CITY OF ST. AUGUSTINE CORRIDOR REVIEW COMMITTEE

**CITY OF ST. AUGUSTINE CORRIDOR REVIEW COMMITTEE
STAFF REPORT AND RECOMMENDATION
Prepared for the June 26, 2025 Meeting**

Application: HP2025-0047

Address: 241 W. King Street

WALL SECTION 2 - THRU CANOPY 3/4"=1'-0" 2

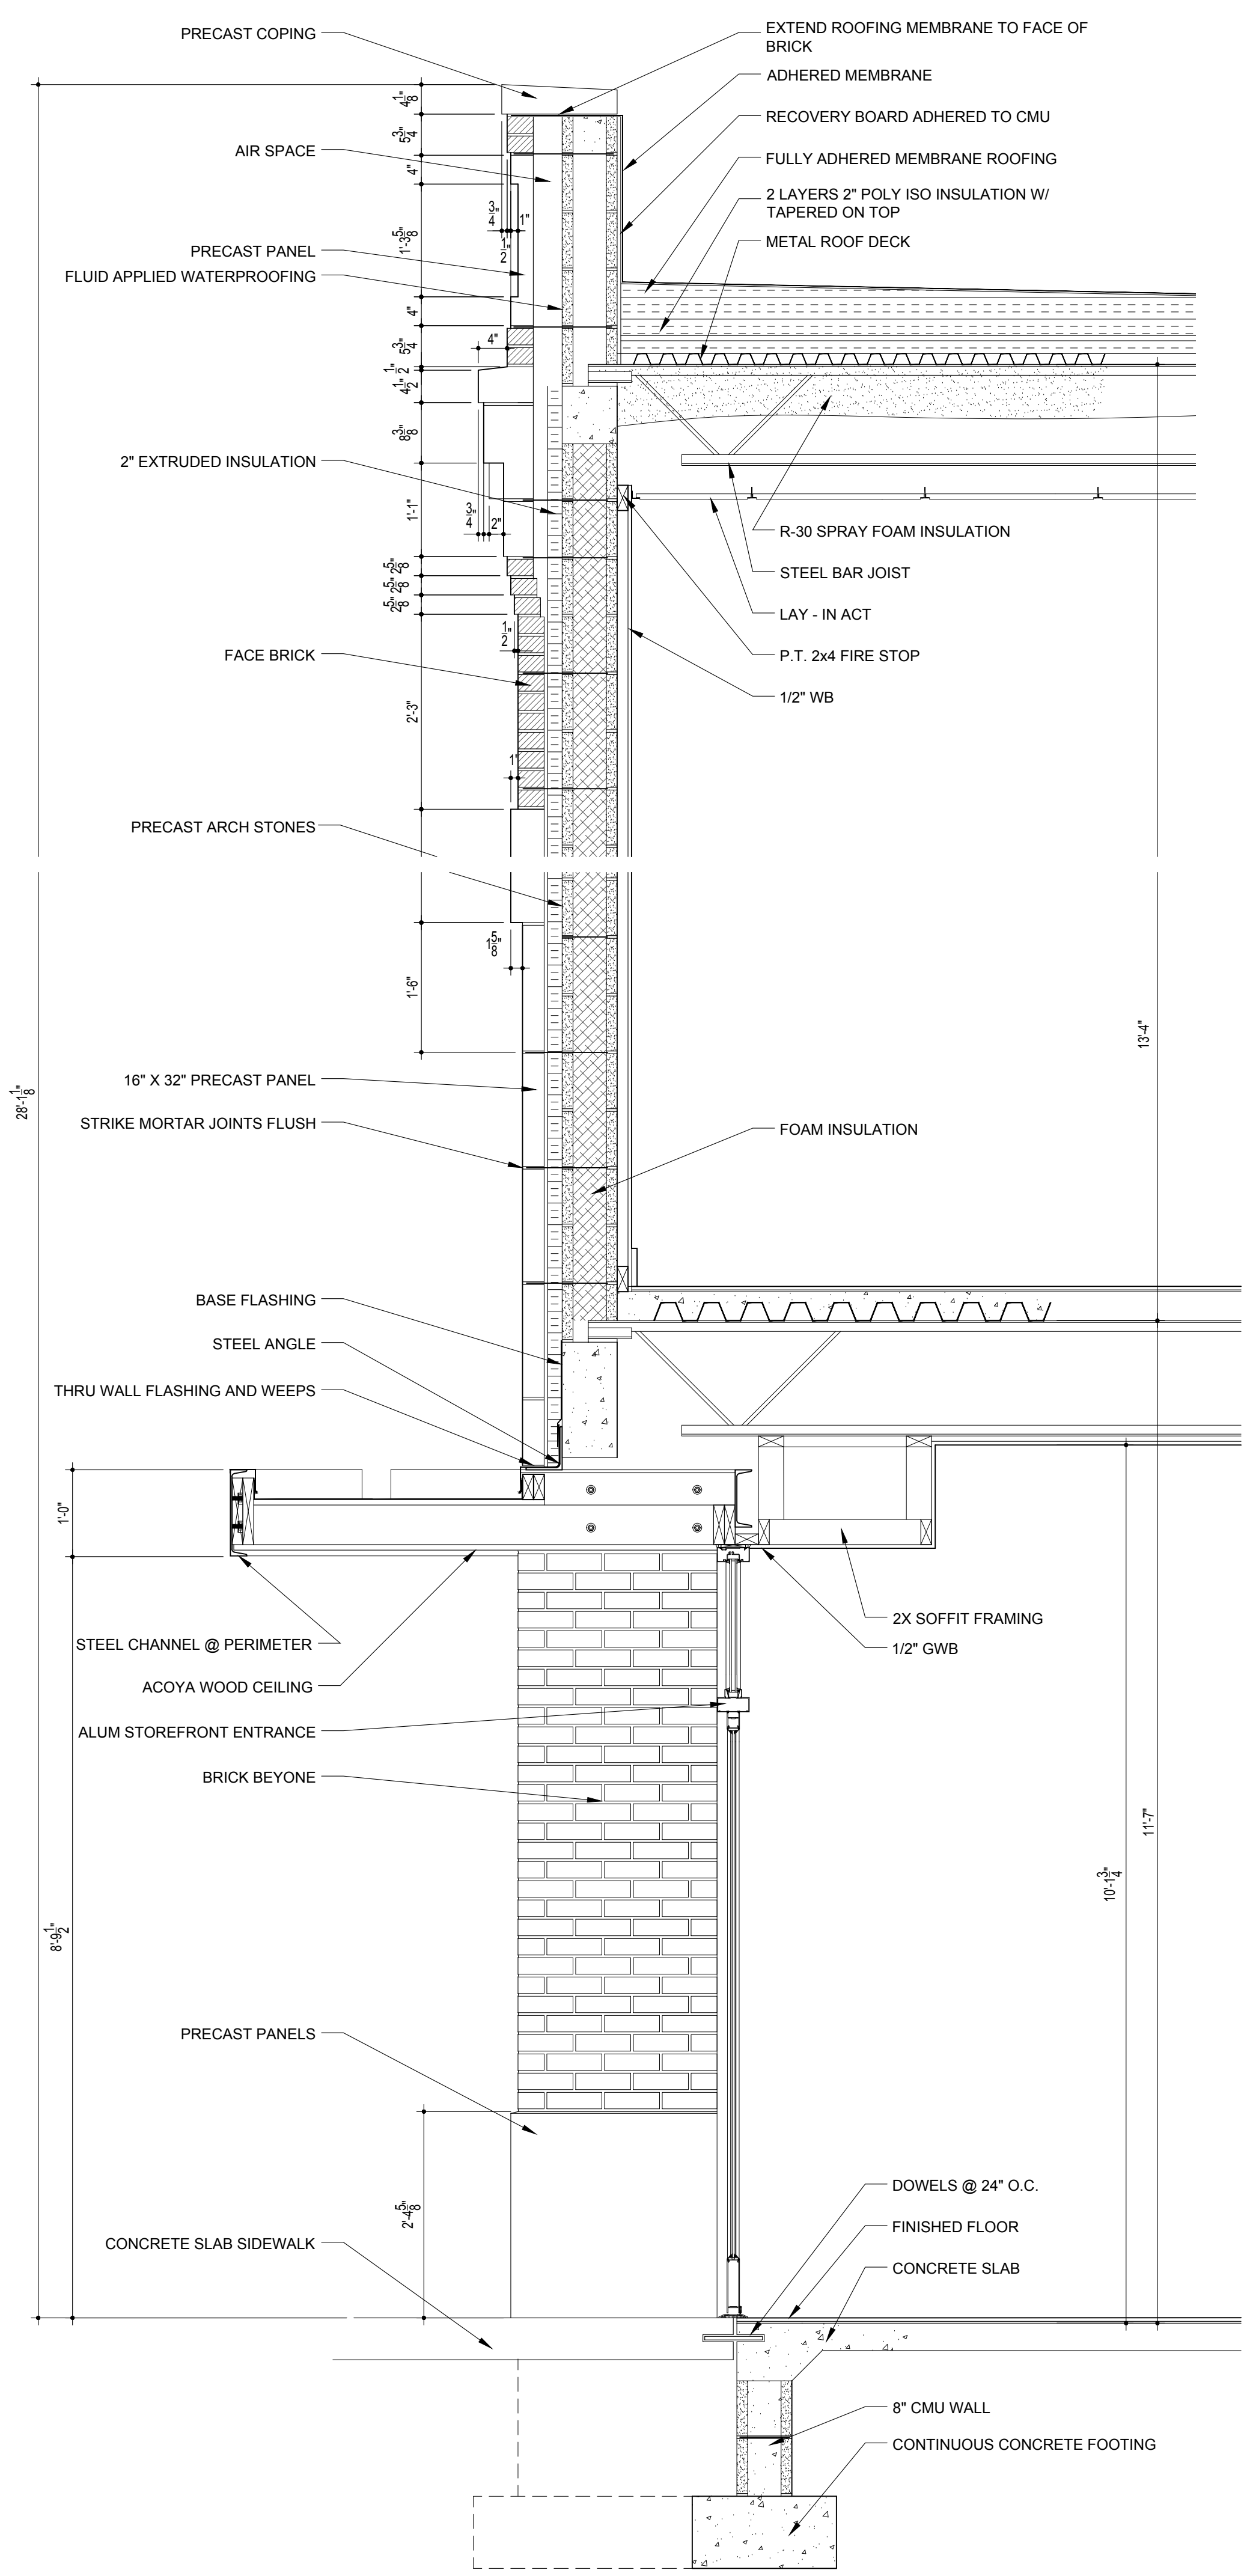
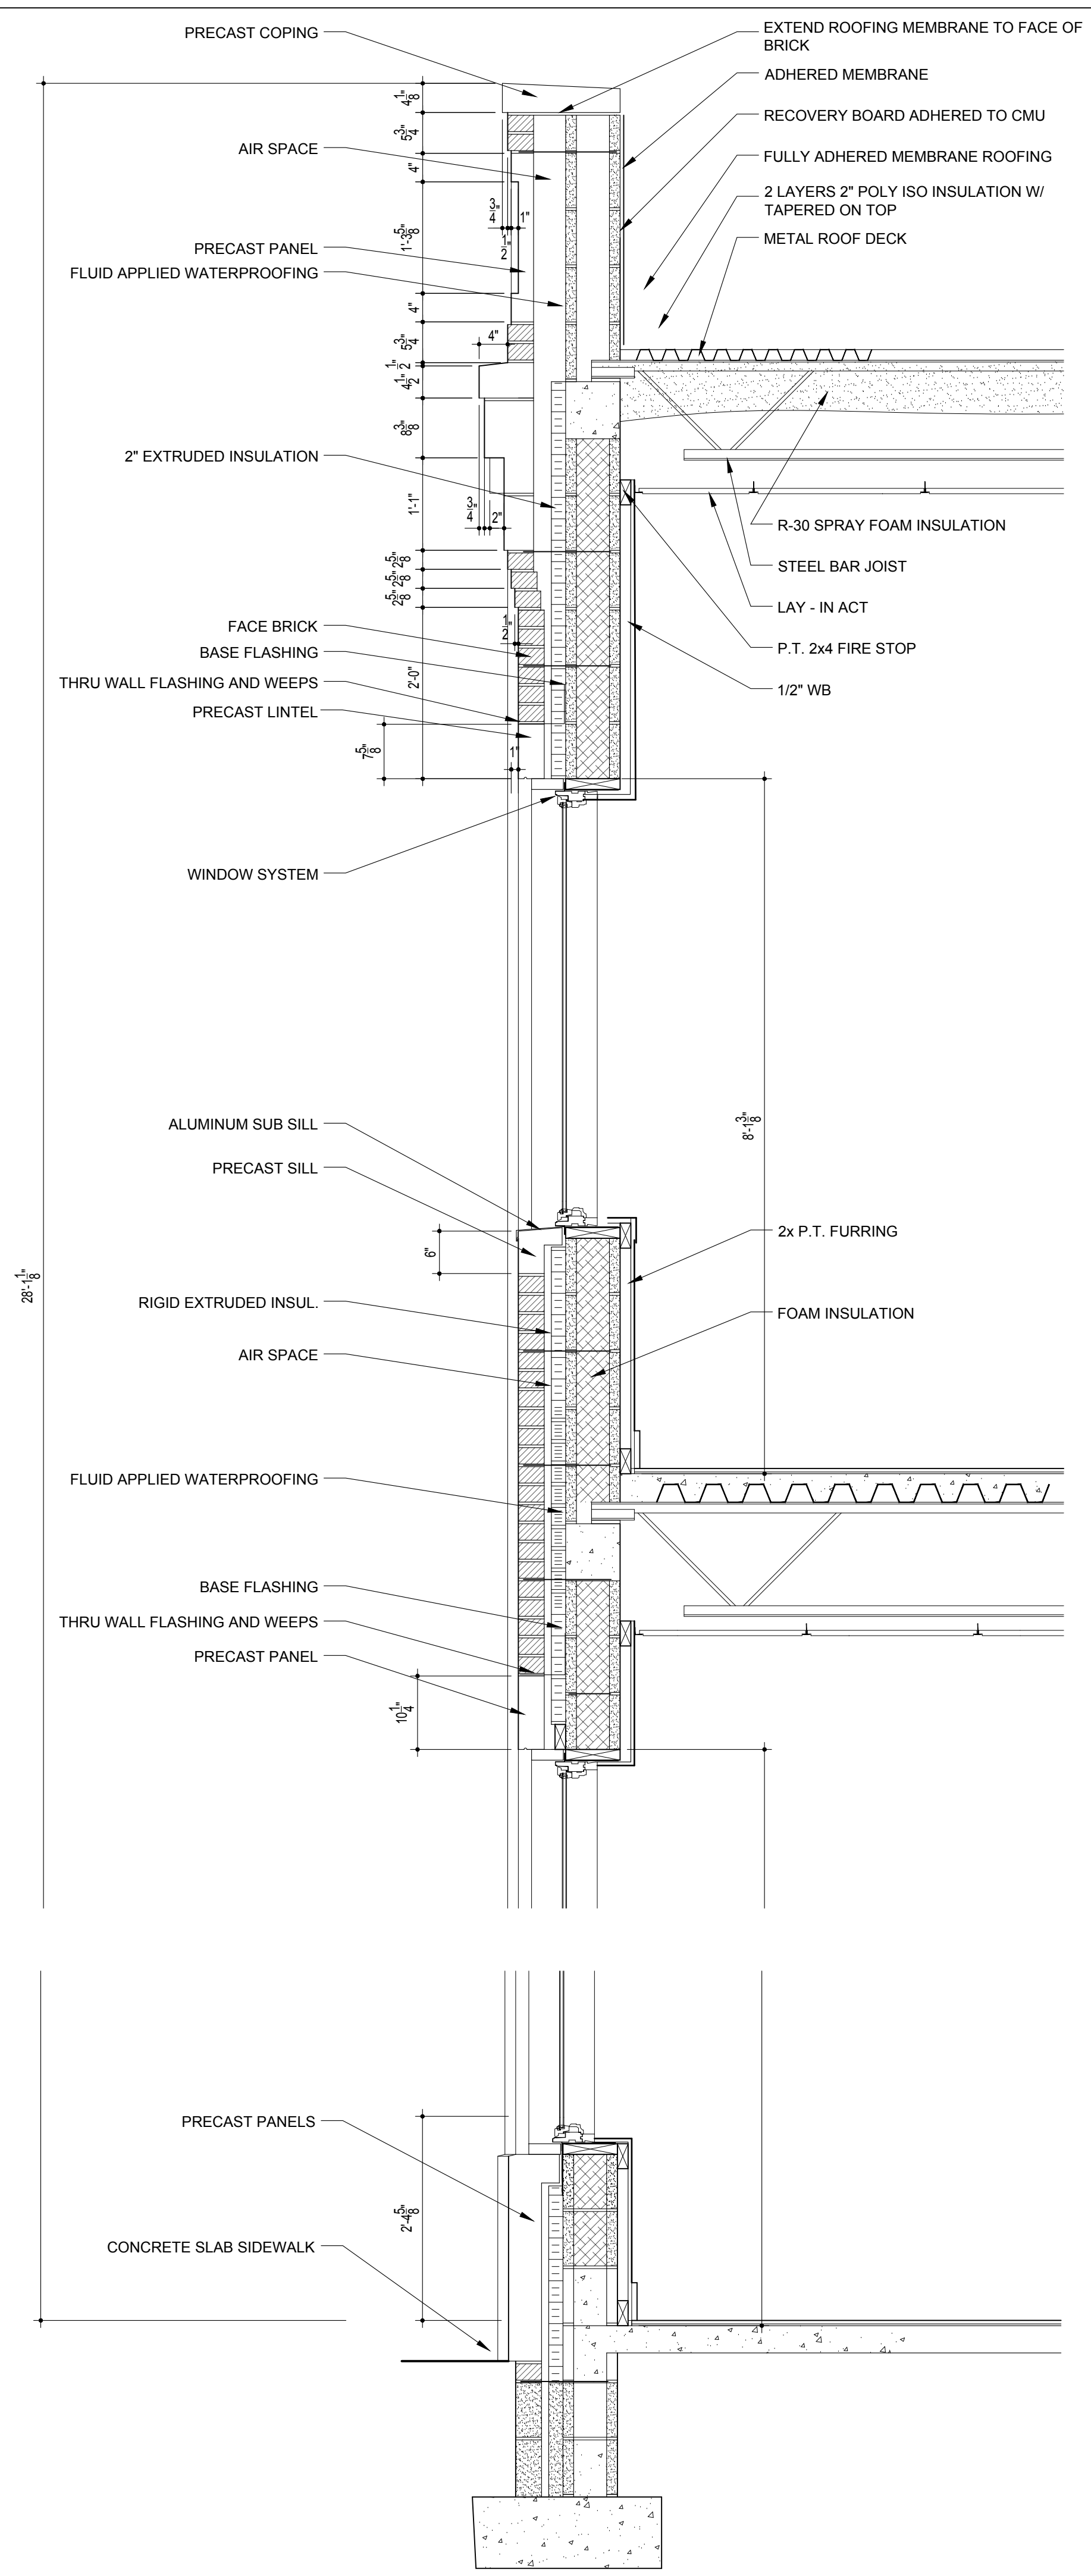
10. An aluminum canopy is proposed across the rear of the building to act as a porte-cochere for the rear entrance to the building.
